PROPOSED ENHANCEMENTS TO THE PLANT 1 ORE SILO REMOVAL ACTION WORK PLAN, REMOVAL ACTION 13

06/22/94

DOE-1559-94
DOE-FN EPA
19
LETTER

PROPOSED ENHANCEMENTS TO THE PLANT 1 ORE SILOS REMOVAL ACTION WORK PLAN, REMOVAL ACTION 13

DRAWING TITLE
MECHANICAL
SECTIONS AND DETAILS
HOISTING ASSEMBLY

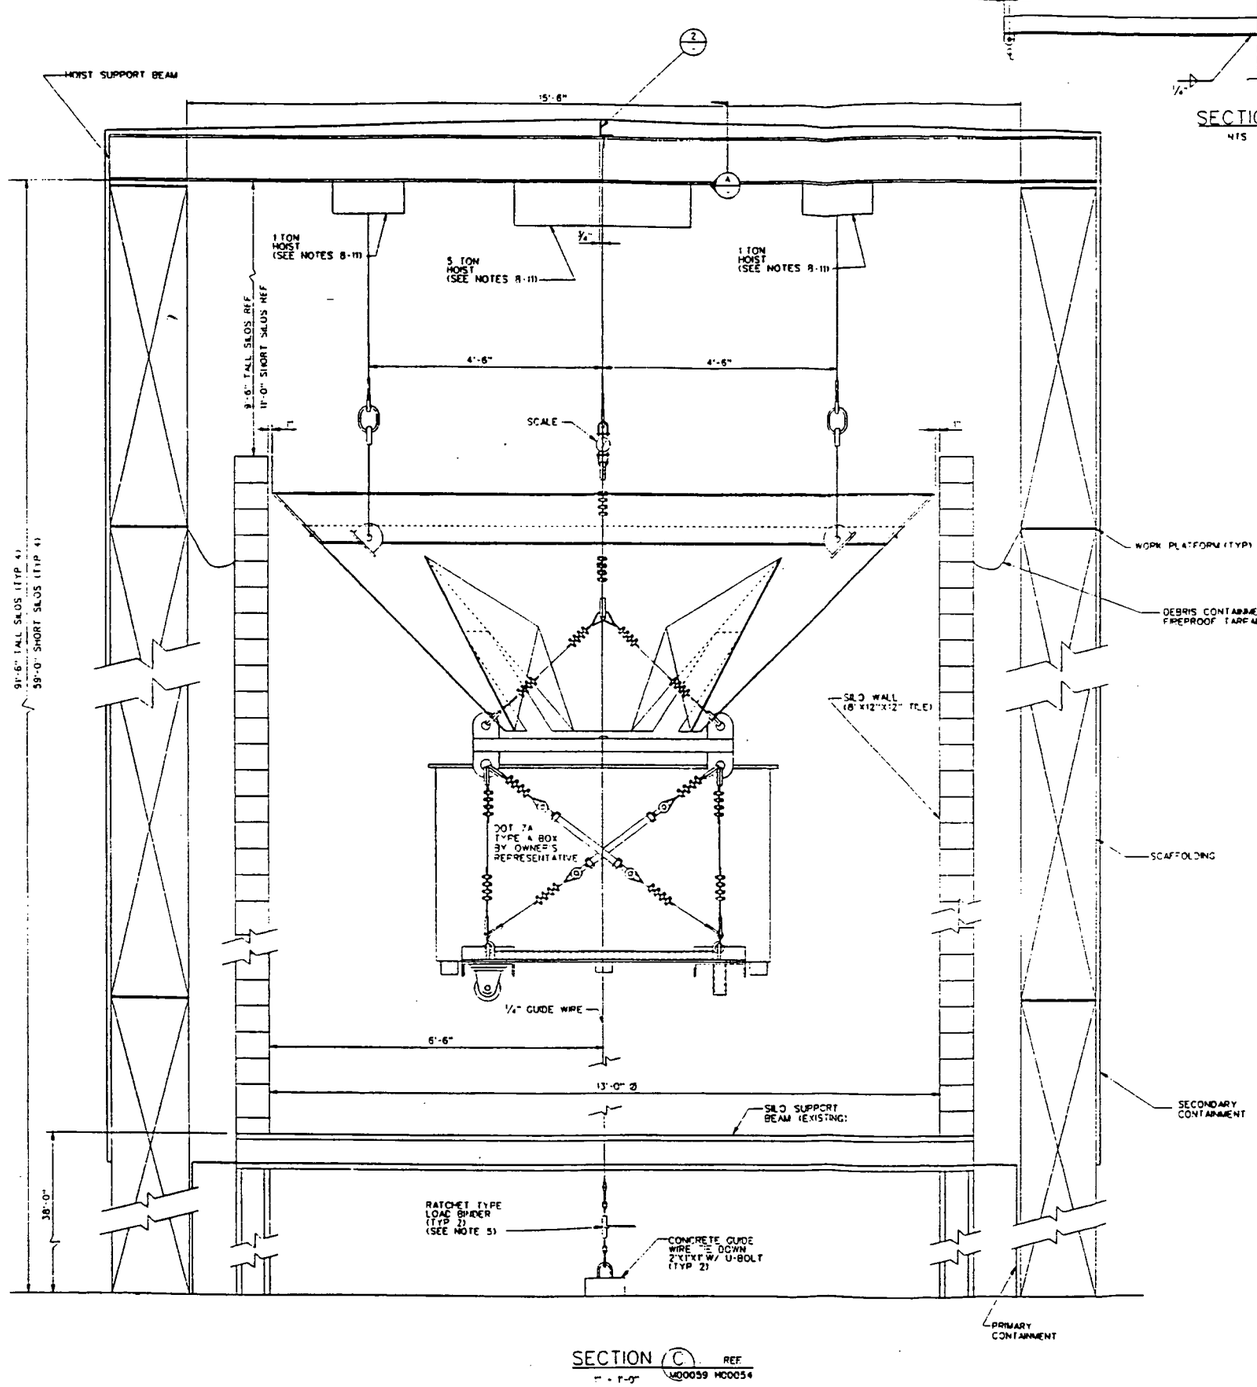
1. Modifications address the safety concern of the present design requiring workers to pull full boxes of debris out from under the silo and the suspended debris slide which is a live load.

The proposed change is to delete the suspended debris slide and provide a system of collecting the dislodged tiles through the existing cones with the addition of a chute. Gross contamination will be removed from the cones prior to use. The debris is then discharged directly into white metal boxes on the slab. Movement of these boxes will be facilitated by use of a system of rollers, out through an air lock to a fork lift pick up station at the end of the roller system.

DWG. NO. SK-M-0310

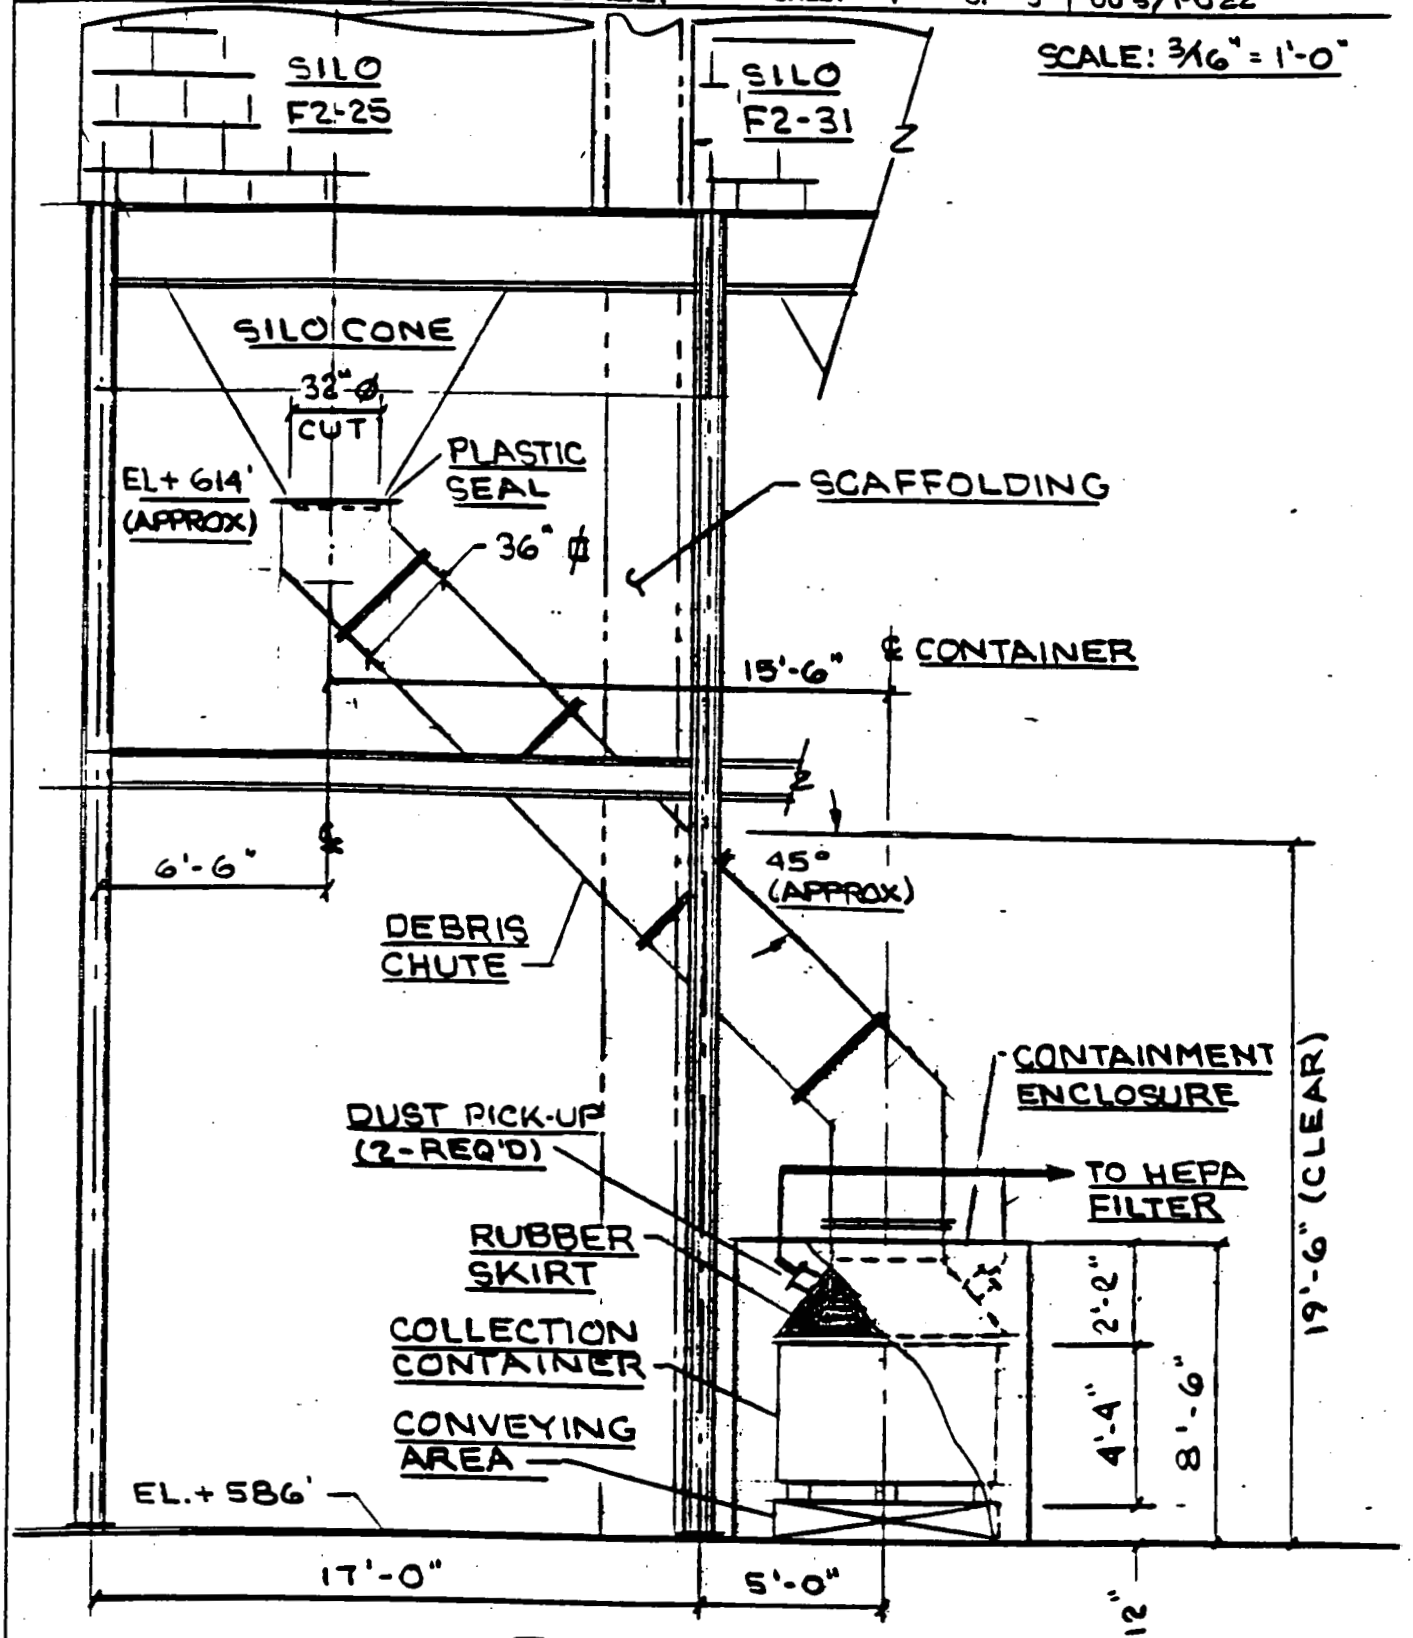
2. An additional 1000CFM HEPA filter unit (estimated size) will be in service to filter a primary containment constructed at the debris entry point to the white metal boxes. The filter unit will capture fugitive dust enhancing both worker safety and environmental control. This set-up would be similar to a drumming station.

DRAWING TITLE
HVAC
PLAN AND SECTIONS
TILE SILO CONTAINMENT

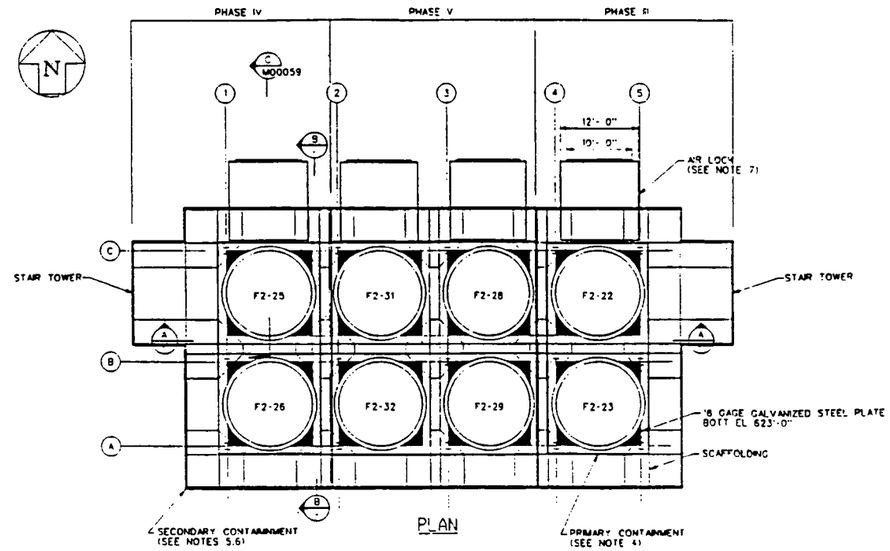
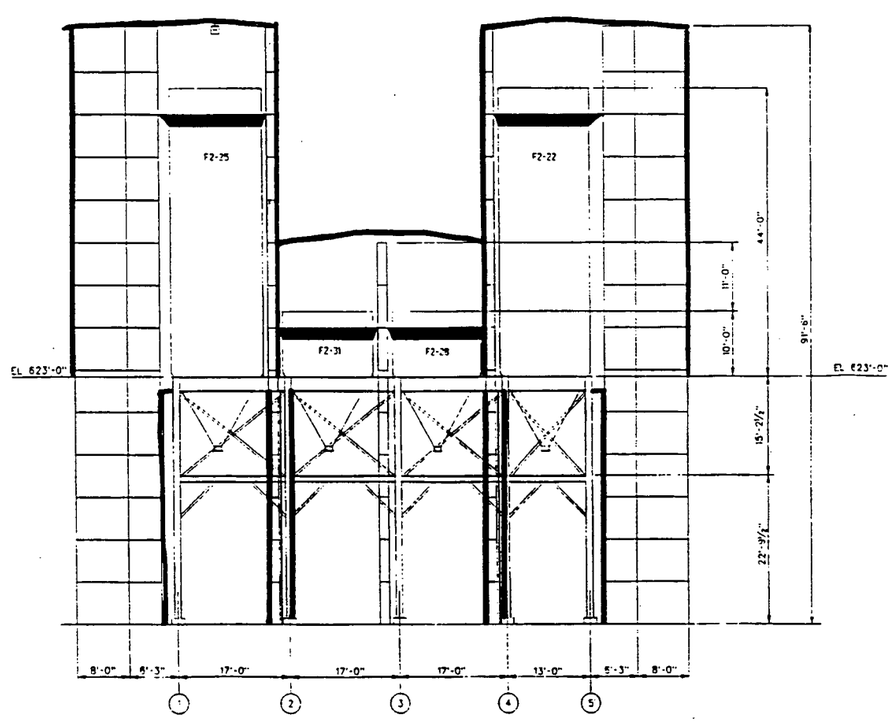
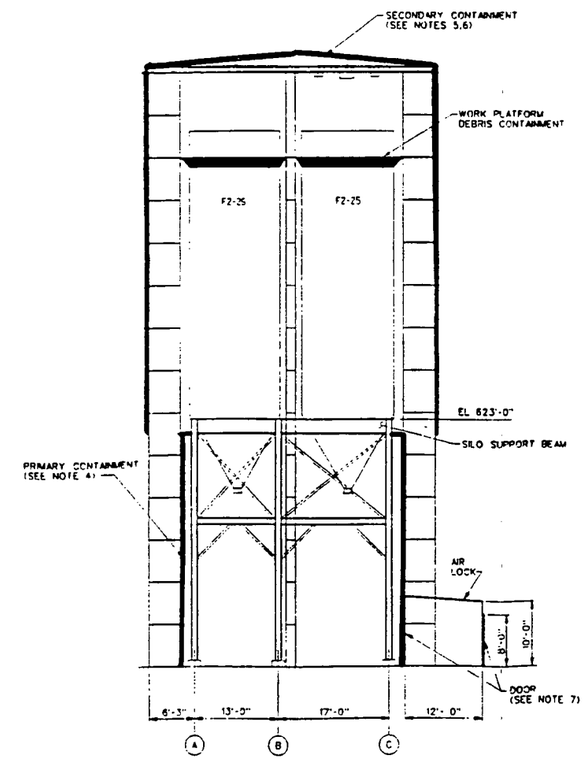
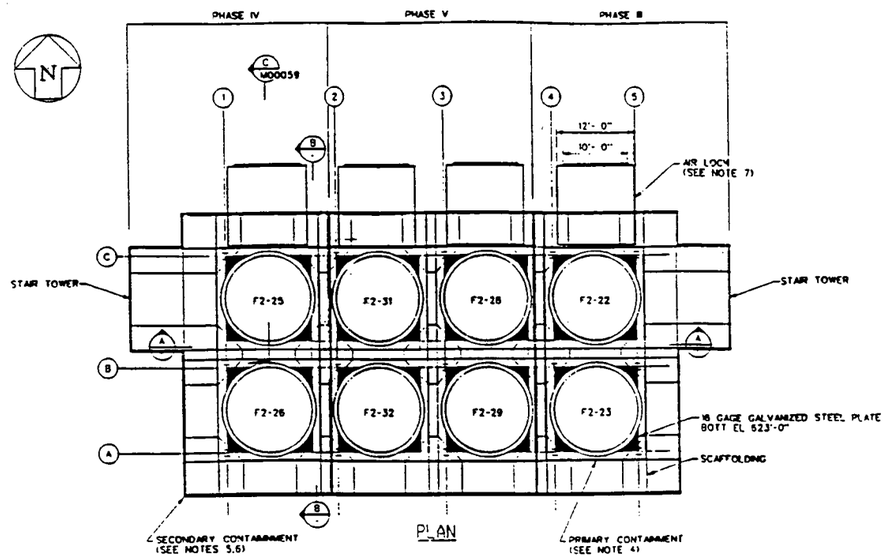
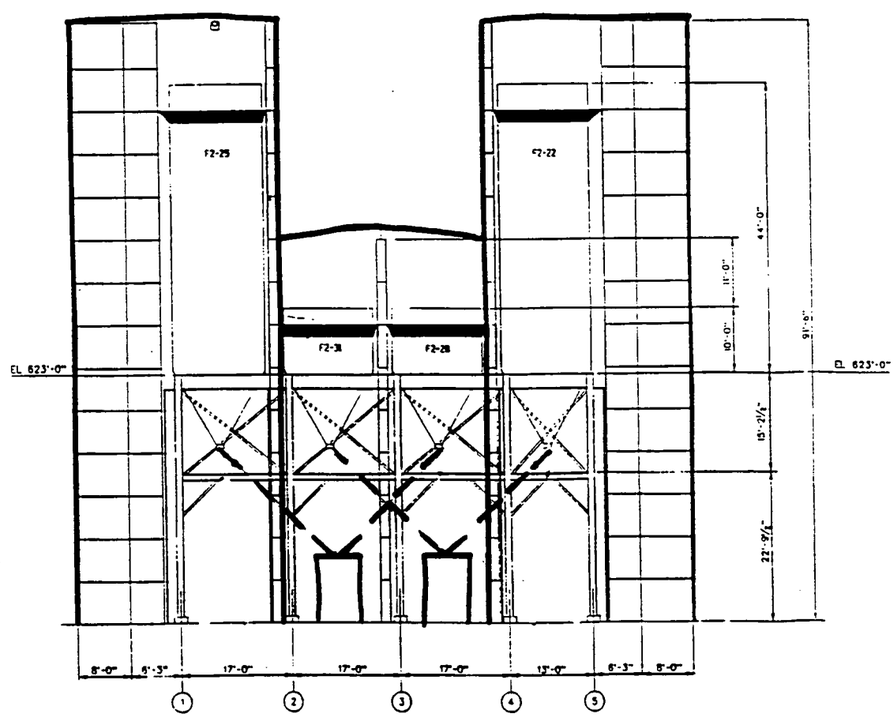
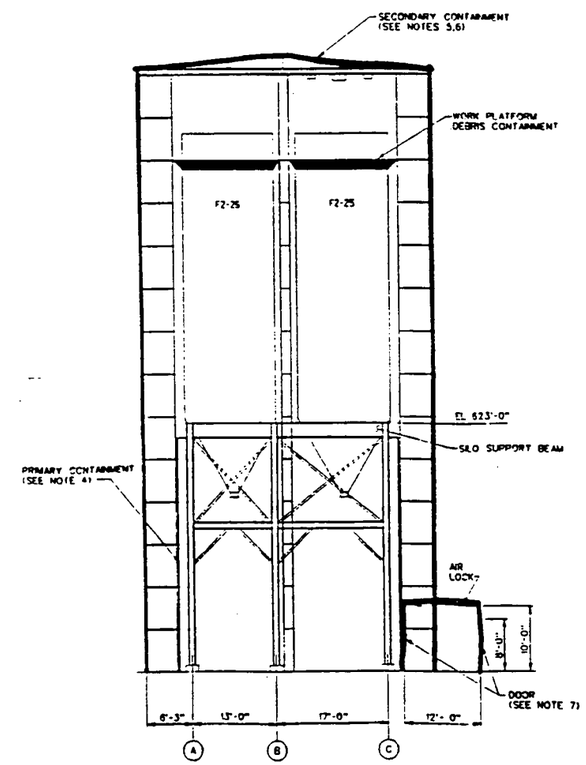
1. The outer plastic sheeting will now be extended to the bottom of the silo areas to better contain fugitive emissions and establish a proper negative air balance to contain these emissions.
